AP 530307-C

Percolation Information- Regan Property

DATE <u>11/27/13</u>	PROJECT No. <u>2171</u>
ATTENTION <u>Jeff Williams</u>	
RE: <u>Rocan Lot 3</u>	
<u>Revised Perc Cert</u>

OWNER/BUILDER:	BENCHMARK ENGINEERS & LAND SURVEYORS & PLANNERS ENGINEERING, INC. 8480 BALTIMORE NATIONAL PIKE SUITE 315 ELLICOTT CITY, MARYLAND 21043 (P) 410-465-6105 ▲ (F) 410-465-6644 WWW.BEI-CIVLENGINEERING.COM	
PROJECT:	REGAN PROPERTY LOT 3	
LOCATION:	12340 POINT RIDGE DRIVE HIGHLAND, MD 20777 TAX MAP No. 34 - BLOCK No. 24 - PARCEL No. 200 5TH ELECTION DISTRICT, TAX ID NUMBER: 05 597436	
TITLE:	REVISED PERCOLATION CERTIFICATION PLAN	
HOUSE TYPE:	HAWTHORNE - ELEVATION B	
DATE:	NOVEMBER, 2018	PROJECT NO. 2171
SCALE:	AS SHOWN	DRAWING <u>1</u> OF <u>1</u>

PLAN VIEW
1" = 50'

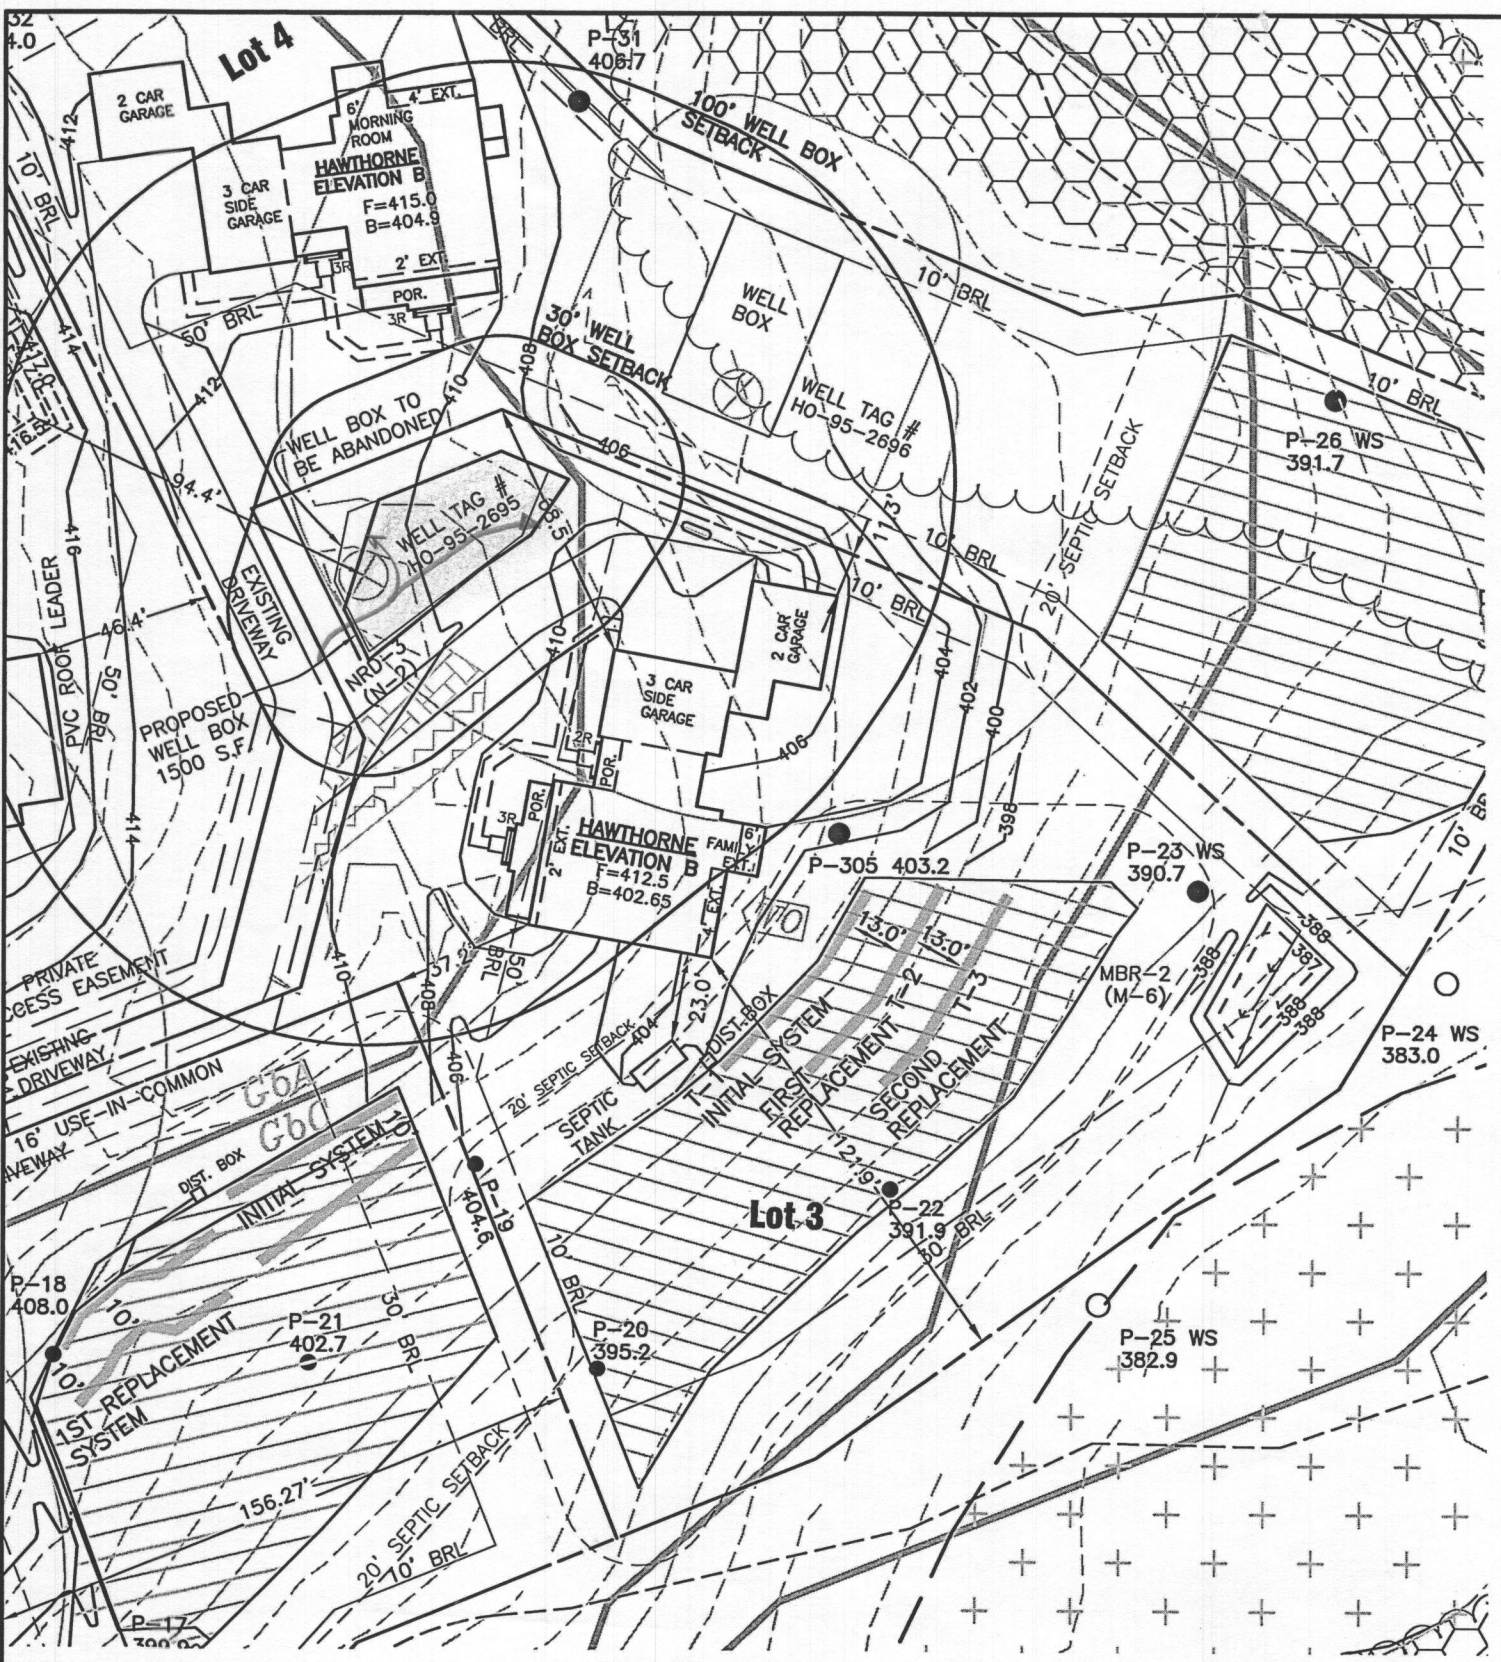
REMARKS: Jeff this is the property we
spoke about on 11/13. We have
revised the lot 5 Building Permit
plan to remove the MTR liner requirement.
This plan revised the well box on Lot 3
to provide as much better as possible.

10. THE PURPOSE OF THIS PLAN IS TO REVISE THE WELL BOX ON LOT 3 DUE TO THE LOCATION AND SIZE OF THE MICRO-BIORETENTION FACILITY ON LOT 5.
11. THIS AREA DESIGNATES A PRIVATE SEWAGE DISPOSAL AREA OF AT LEAST 10,000 S.F. AS REQUIRED BY THE MARYLAND STATE DEPARTMENT OF THE ENVIRONMENT FOR INDIVIDUAL SEWERAGE DISPOSAL. IMPROVEMENTS OF ANY NATURE IN THIS AREA ARE RESTRICTED UNTIL PUBLIC SEWER IS AVAILABLE. THIS EASEMENT SHALL BECOME NULL AND VOID UPON CONNECTION TO A PUBLIC SEWER SYSTEM. THE COUNTY HEALTH OFFICER SHALL HAVE THE AUTHORITY TO GRANT ADJUSTMENTS TO THE PRIVATE SEWERAGE EASEMENT. RECORDATION OF A MODIFIED SEWERAGE EASEMENT PLAT SHALL NOT BE REQUIRED.

PLAN VIEW
1" = 50'

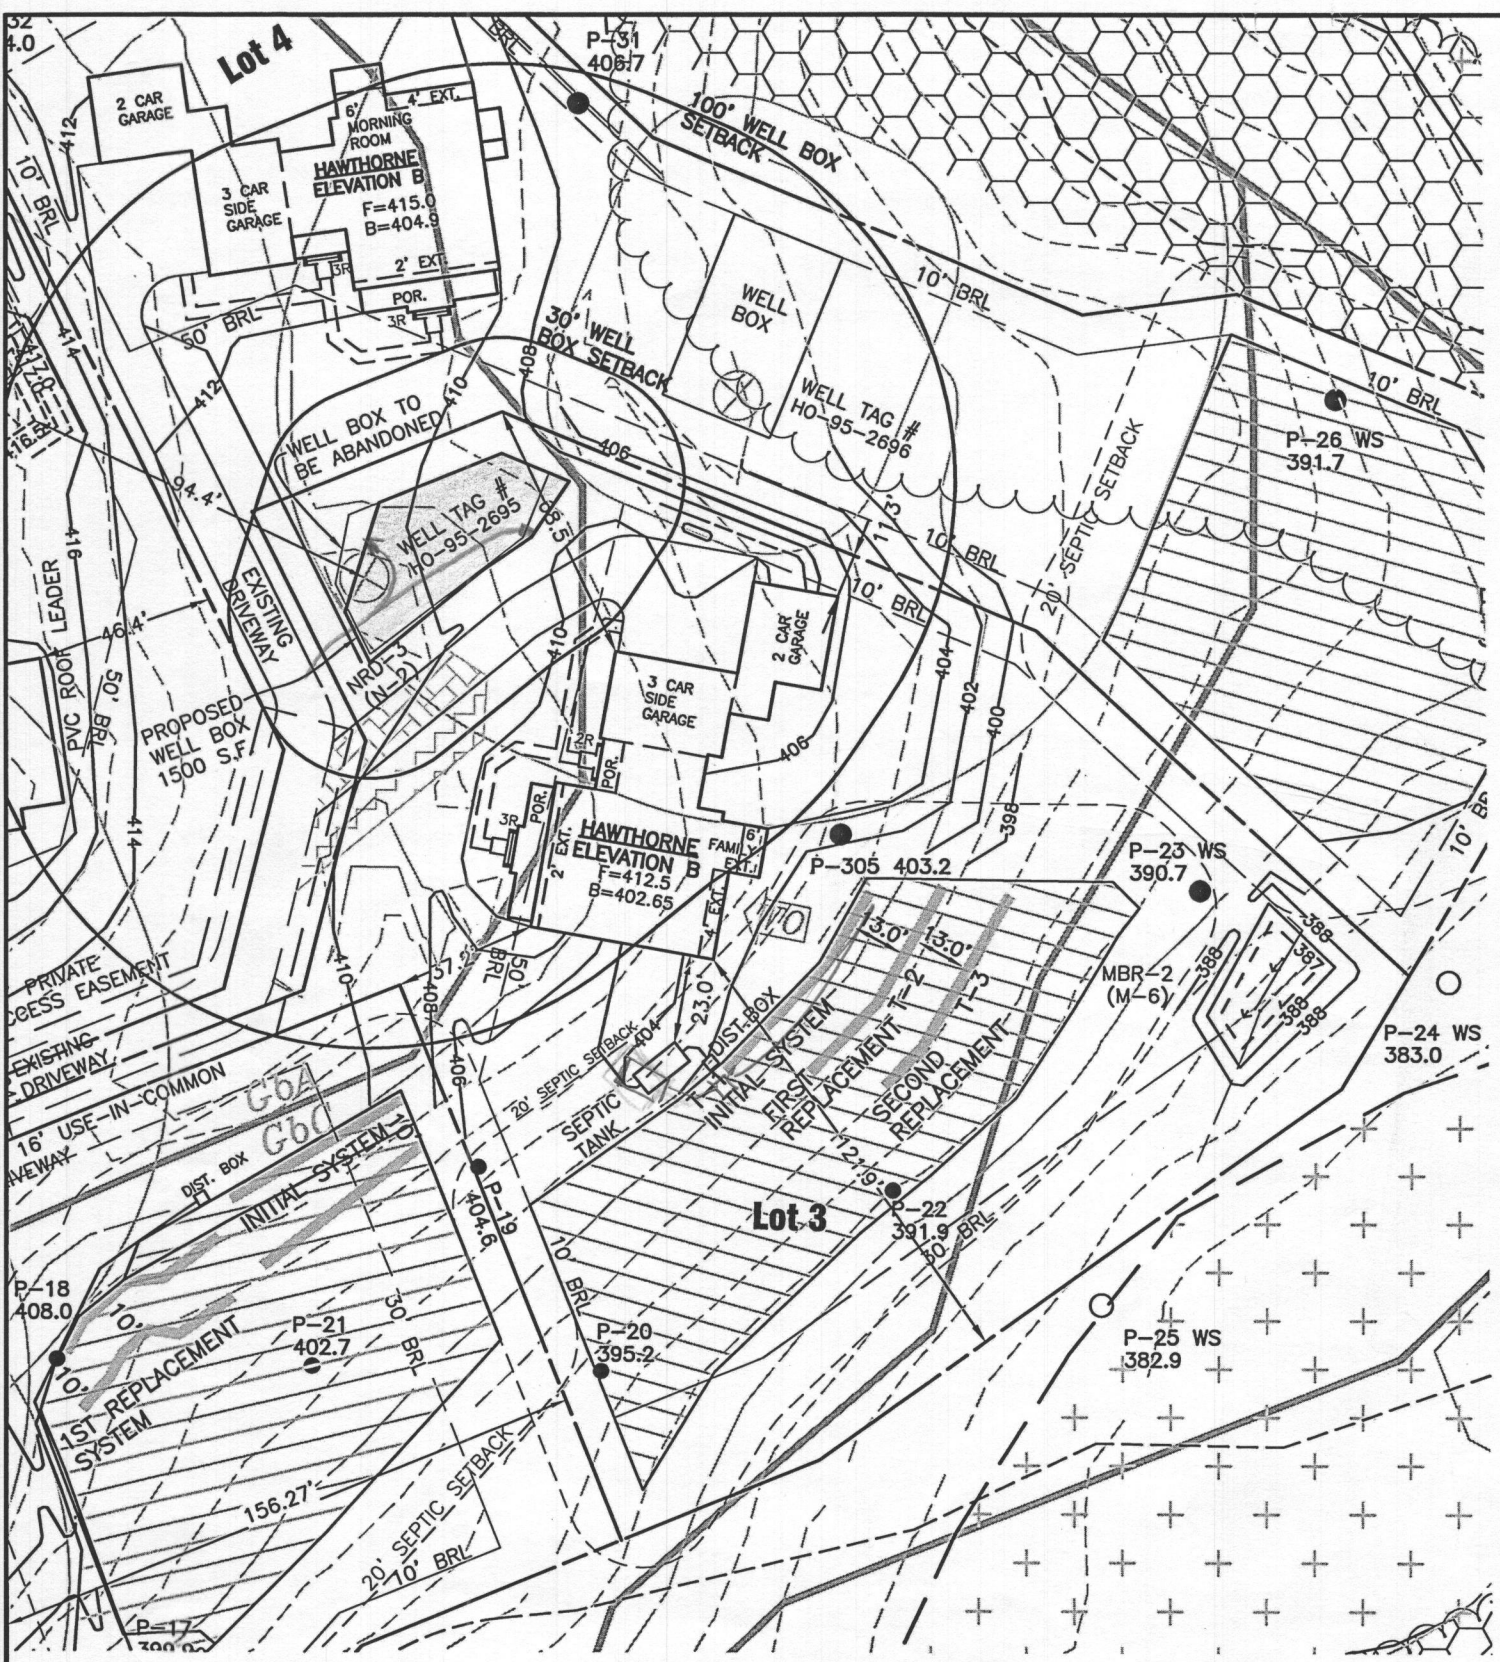
10. THE PURPOSE OF THIS PLAN IS TO REVISE THE WELL BOX ON LOT 3 DUE TO THE LOCATION AND SIZE OF THE MICRO-BIORETENTION FACILITY ON LOT 5.
11. THIS AREA DESIGNATES A PRIVATE SEWAGE DISPOSAL AREA OF AT LEAST 10,000 S.F. AS REQUIRED BY THE MARYLAND STATE DEPARTMENT OF THE ENVIRONMENT FOR INDIVIDUAL SEWAGE DISPOSAL. IMPROVEMENTS OF ANY NATURE IN THIS AREA ARE RESTRICTED UNTIL PUBLIC SEWER IS AVAILABLE. THIS EASEMENT SHALL BECOME NULL AND VOID UPON CONNECTION TO A PUBLIC SEWER SYSTEM. THE COUNTY HEALTH OFFICER SHALL HAVE THE AUTHORITY TO GRANT ADJUSTMENTS TO THE PRIVATE SEWAGE EASEMENT. RECORDATION OF A MODIFIED SEWAGE EASEMENT PLAT SHALL NOT BE REQUIRED.
